# AEMO review of technical requirements for connection

26 July 2023

Appendix A2 to Draft  
Recommendations Update Report –  
Schedules 5.2 & 5.3a of the National  
Electricity Rules (Part 1) – Draft NER  
amendments

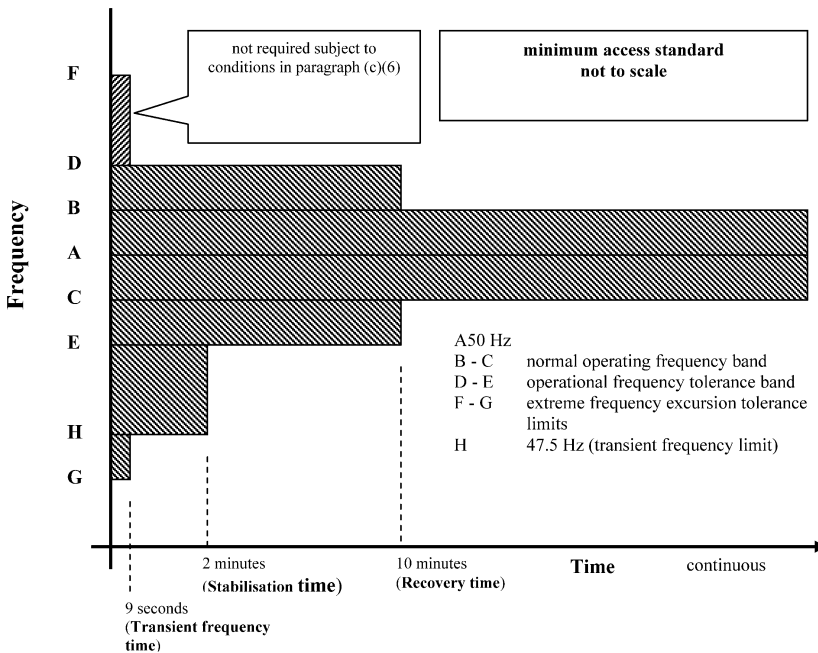
**Commented [A41]:** Feedback sought on whether this remains appropriate for Tasmania
